CIRCA 1795 GEORGE SPENCER HOUSE
WARREN SQUARE, 22 HABERSHAM STREET
SAVANNAH, GEORGIA

Re: Mills Lane c.1795 Spencer House
Project No. 92013

Re: c.1795 George Spencer House
22 Habersham Street
Project No. 92013

THE SPENCER-WOODBRIDGE HOUSE
22 Habersham St., Savannah, Georgia
A Short Restoration Summary

Revised East Rear - Low - Specs 26 May '92
(retain 20th c. steel rm, change window + roof trim) HJ
New porch, put blinds back on.

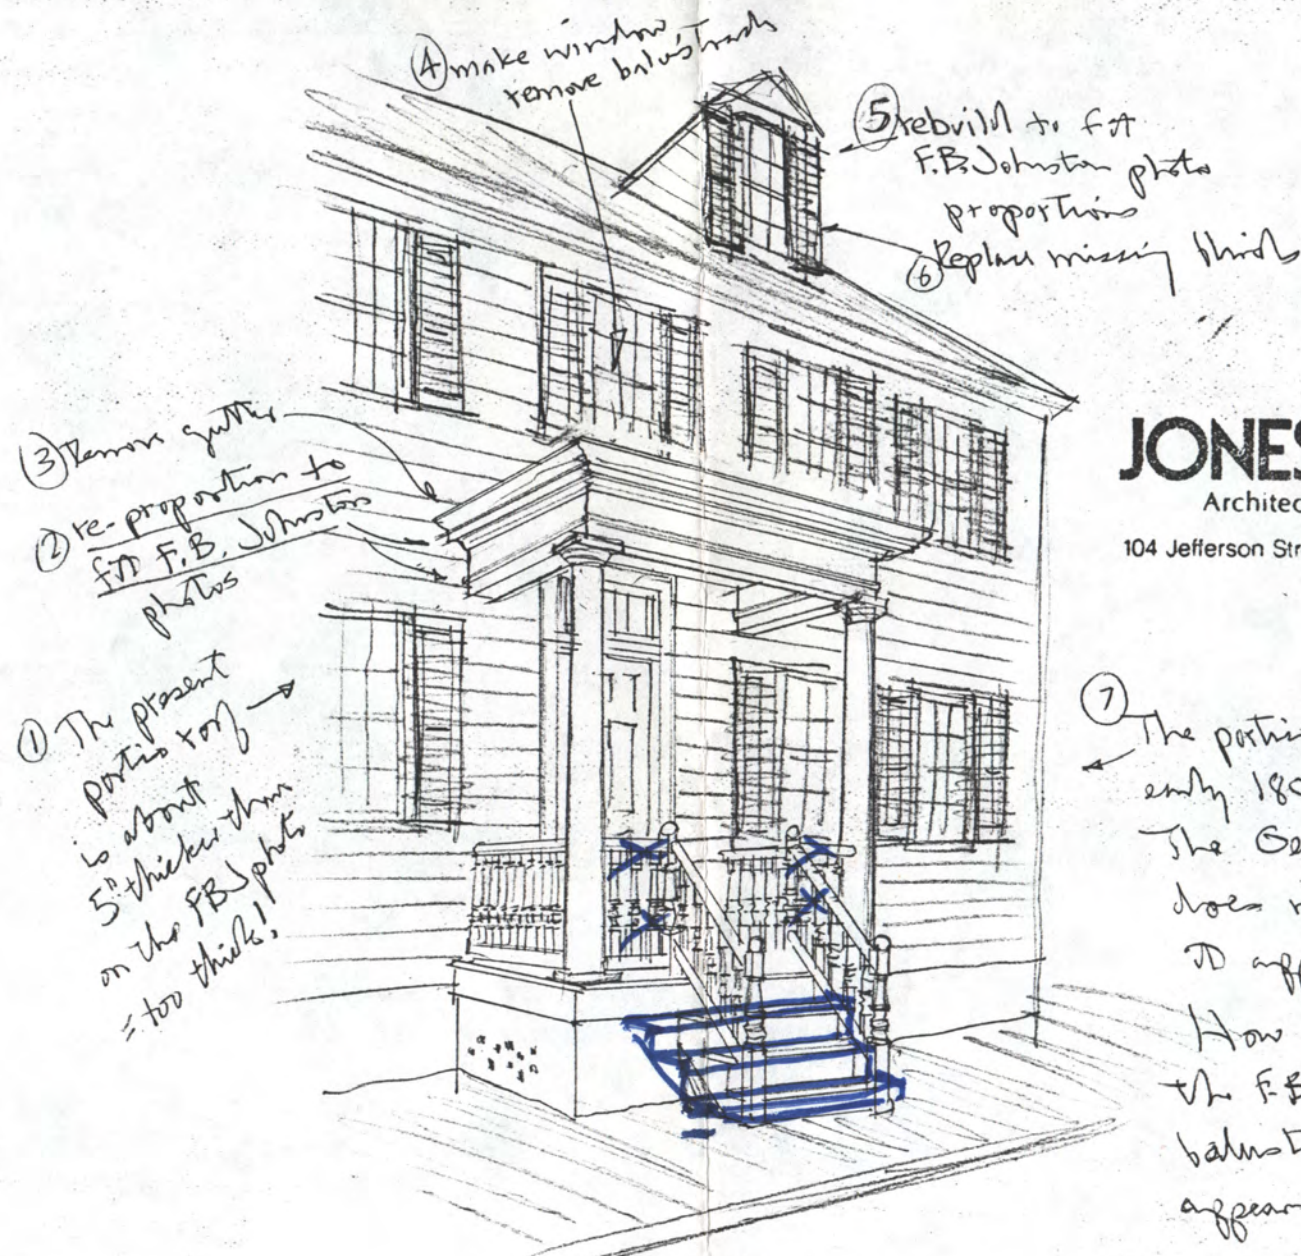
7) The porch is apparently early 1800's Fed.
The Georgian balustrade does not fit, it appears.
How about replicating the F.B. Johnston balustrade, which appears Fed.?

Francis
Derwin
Johnston
photo

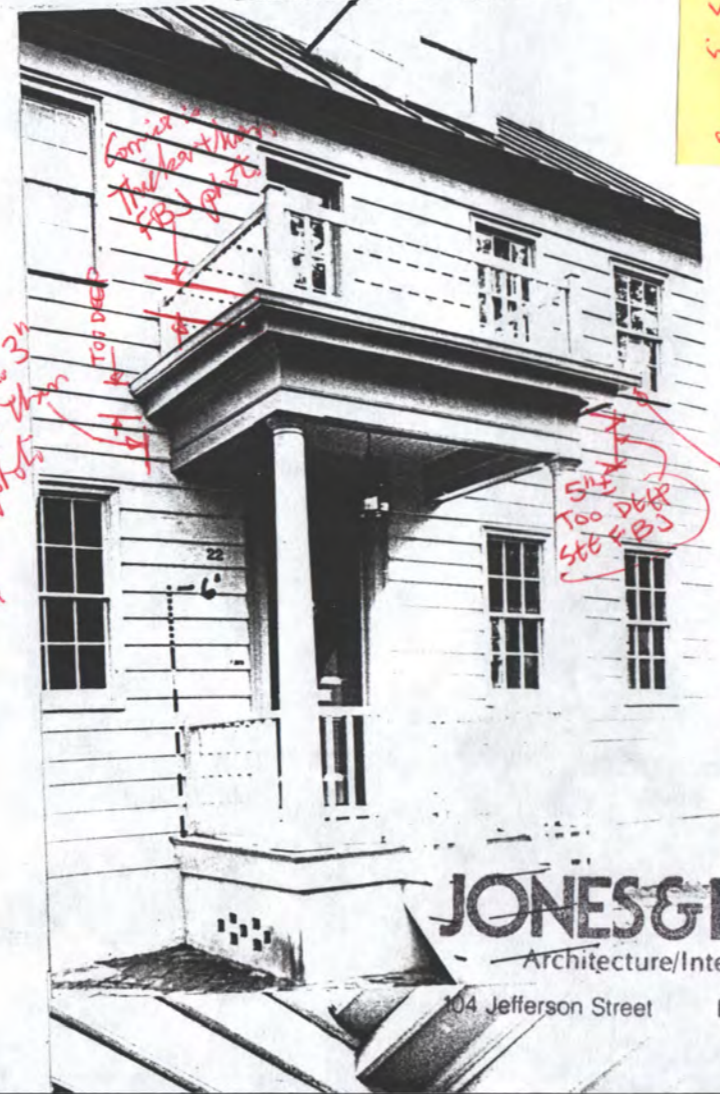
projections
 $\pm 1/4"$ on FBJ photo,
 $\pm 1/2"$ w.
AS REBUILT:
Dormer looks
flat & dead.
Compare w/
F.B. Johnston
photo for
original
config.

too wide. Compare w/ FBJ
note like this

6 - shadow indicates
a beak-panel mould
less, under water

7 - width = good proportion, not like now
1 - shadow indicates this
is at least $1/4"$ deep,
looks much better
than present $3/4"$
2 - shadow indicates
sash is set back
2 or more inches
from face = much
better than present $3/8"$
3 - Note blind-hinges.
Do you want to
put blinds back on?

Rebuilt dormer
are poorly proportioned
while those
in the F.B. Johnston
photo. Would be
good to rebuild

Eave
is
approx 3"
wider than
FBJ photo
= too wide

Correct
the lead
FBJ photo

5 1/2"
Too deep
see FBJ

modern
eye
gutter.
Was a
cornice-mould
See FBJ photo

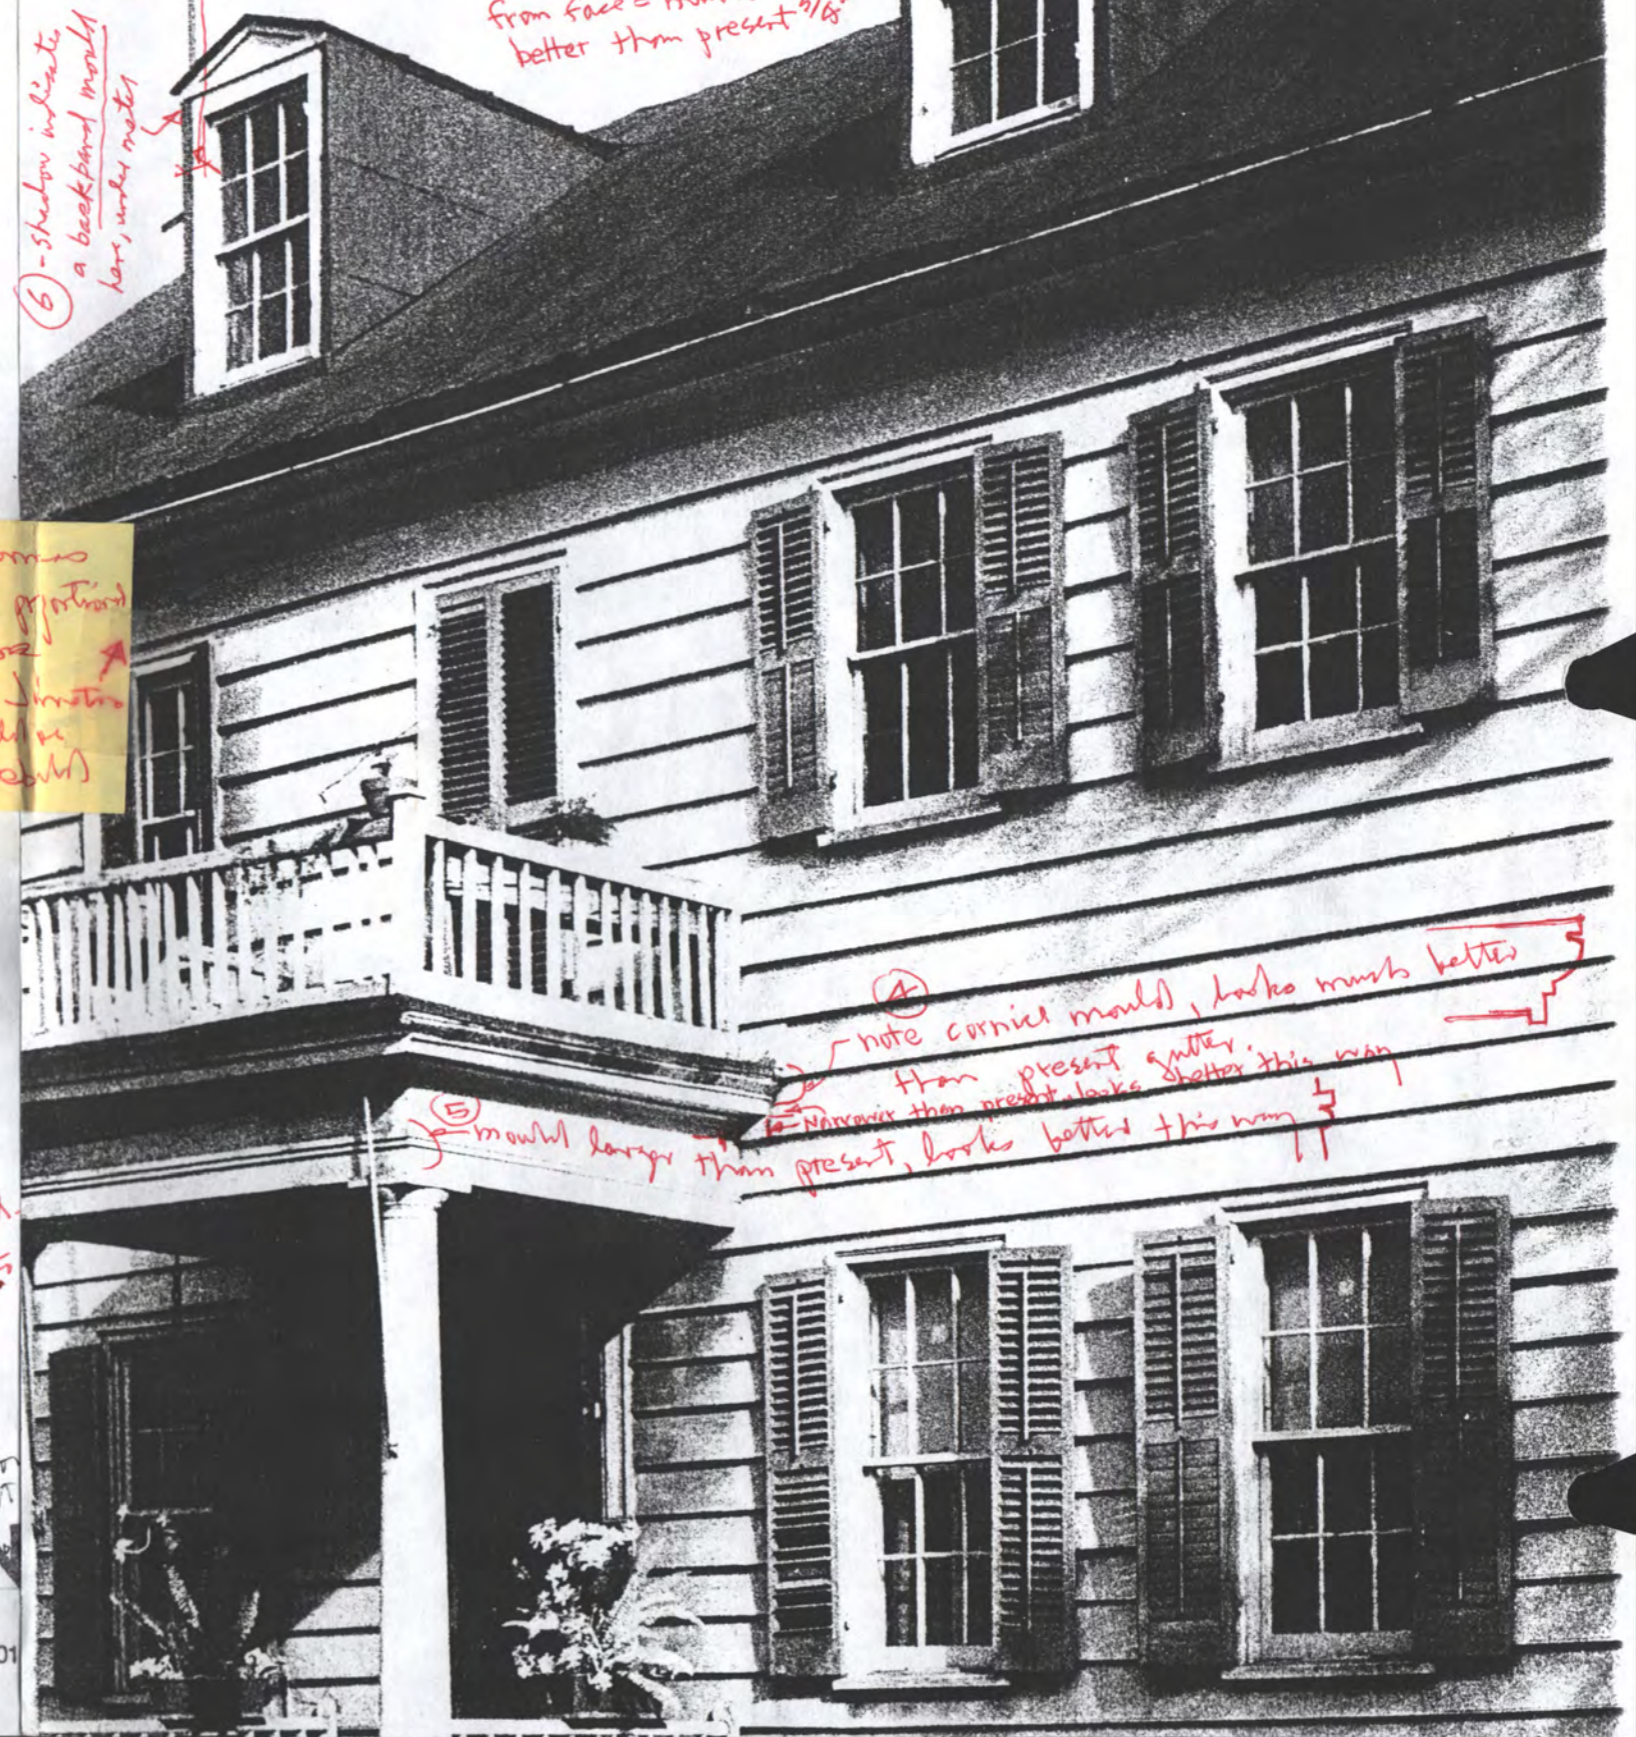
4 - note cornice mould, looks much better
than present gutter.
5 - narrower than present, looks better this way
6 - mould larger than present, looks better this way

Plate XL

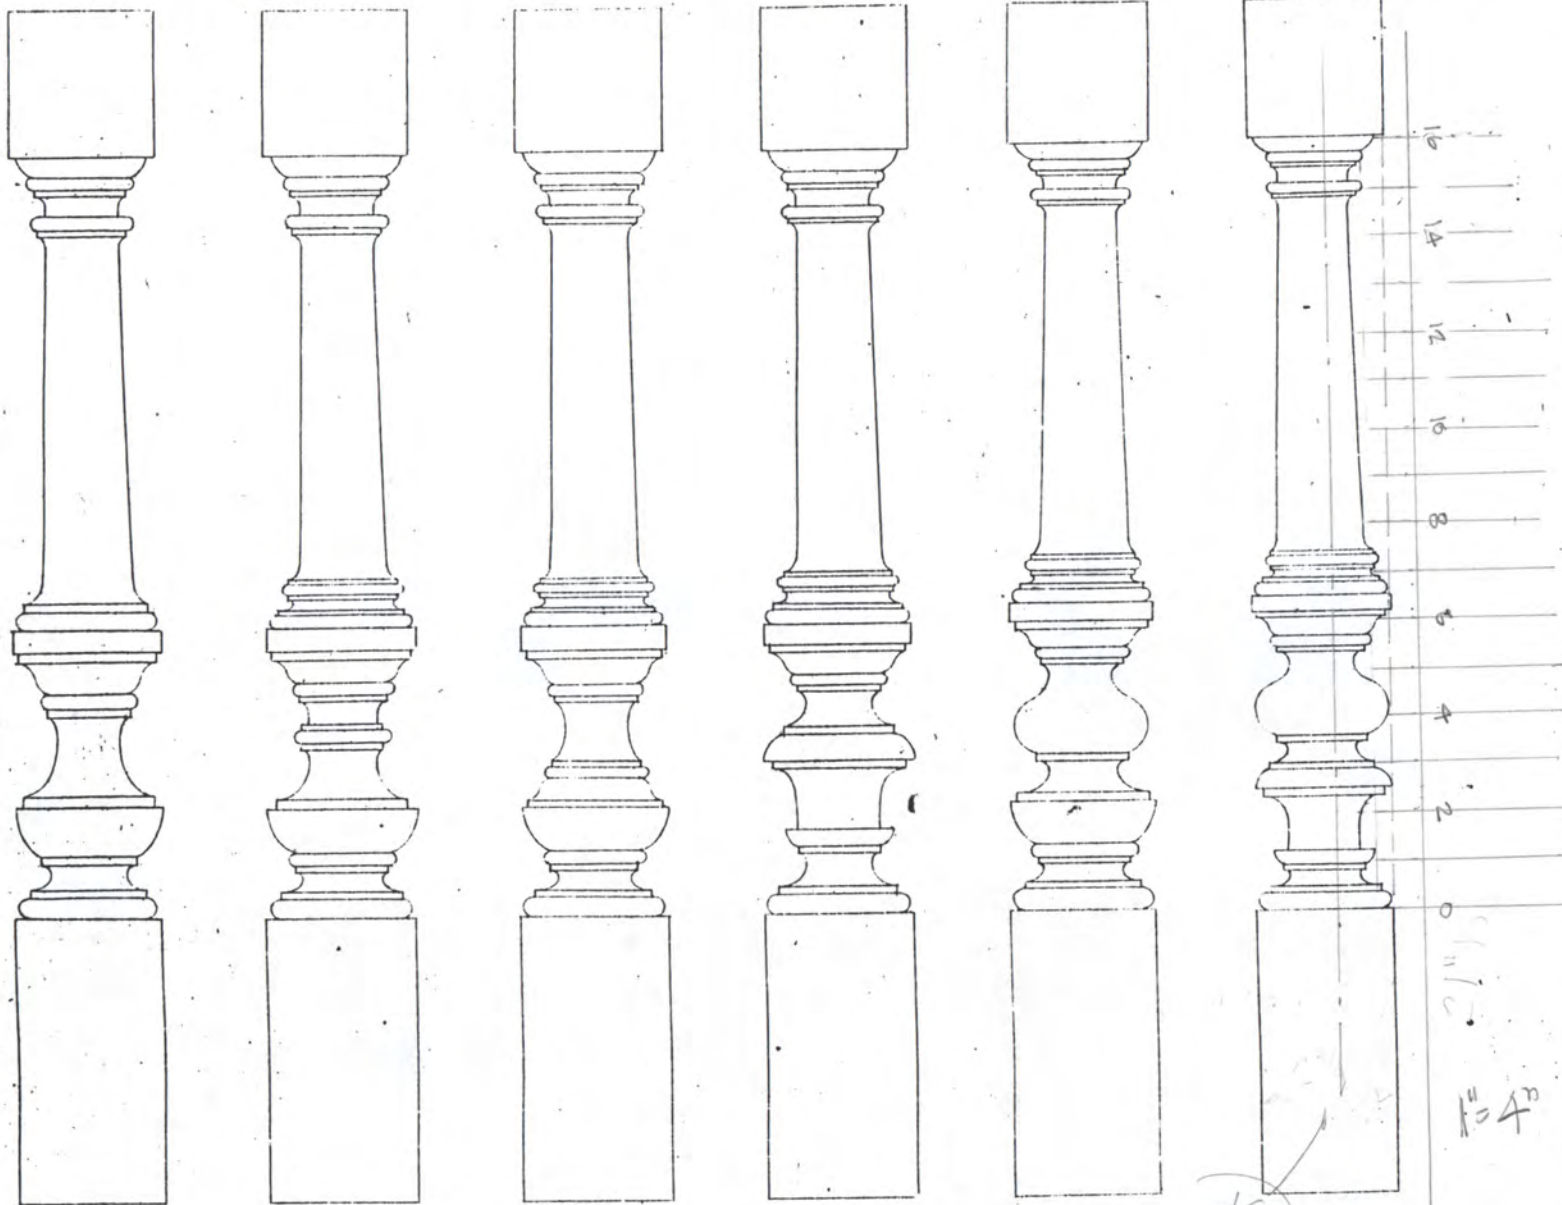
Here's what I'd suggest as model for the balusters on the porch of 22 Habersham Street, the Spencer House. I'd like to see a drawing with balusters like this running across the front of the porch and steps rising for either side. I do not have a model for the handrail, but it should probably be flat and rather heavy rather than round and light. As indicated on the drawings of existing conditions, we should propose removing the balustrade over the porch and return the second-story door to a window. If you wish to subtly alter the proportions of the roof cornice, ? do so.

MAKE
2 1/4"

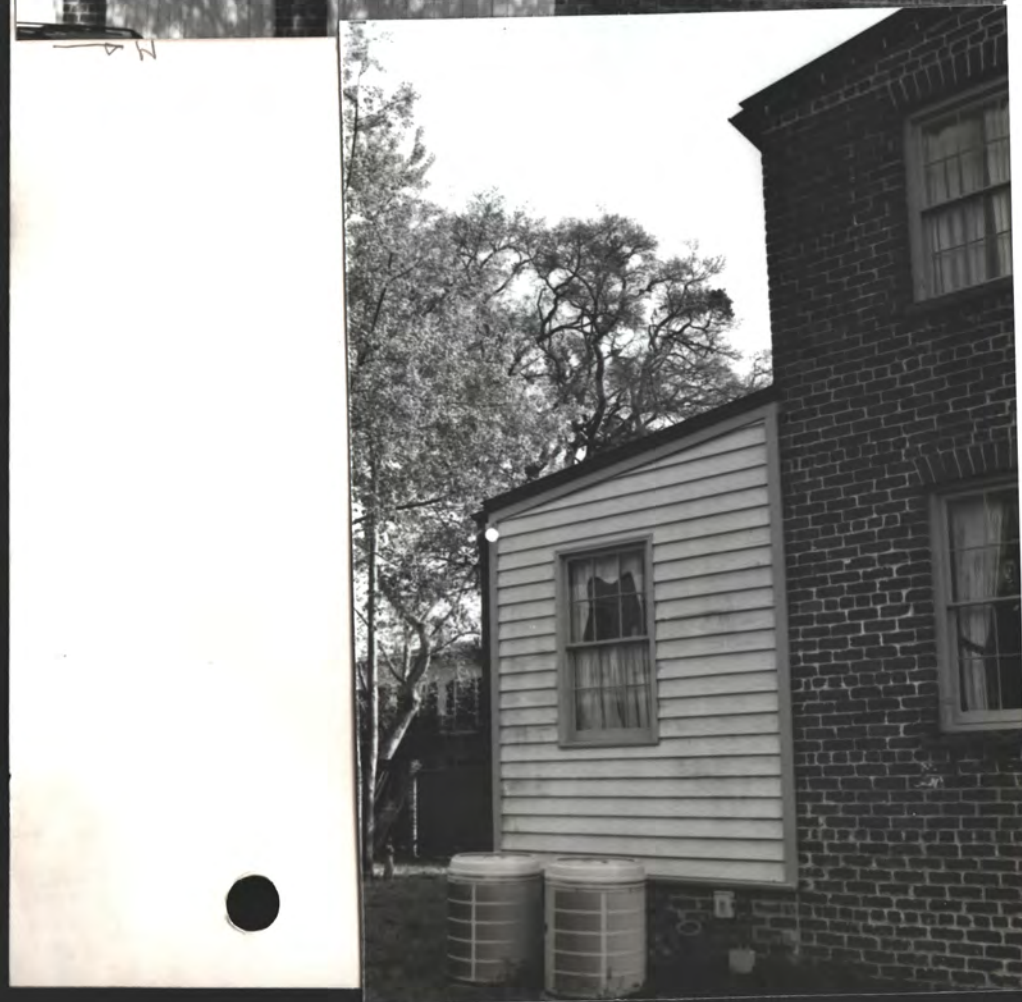
Why?
 no
 + boards
 *boards
 hole =
 not
 likely
 orig
 ()

Palisade-fascia probably modern = $3/4"$ (not $1/8"$),
 no taper, no bottom - bend
 Hole not there in 1930's 1955 photo
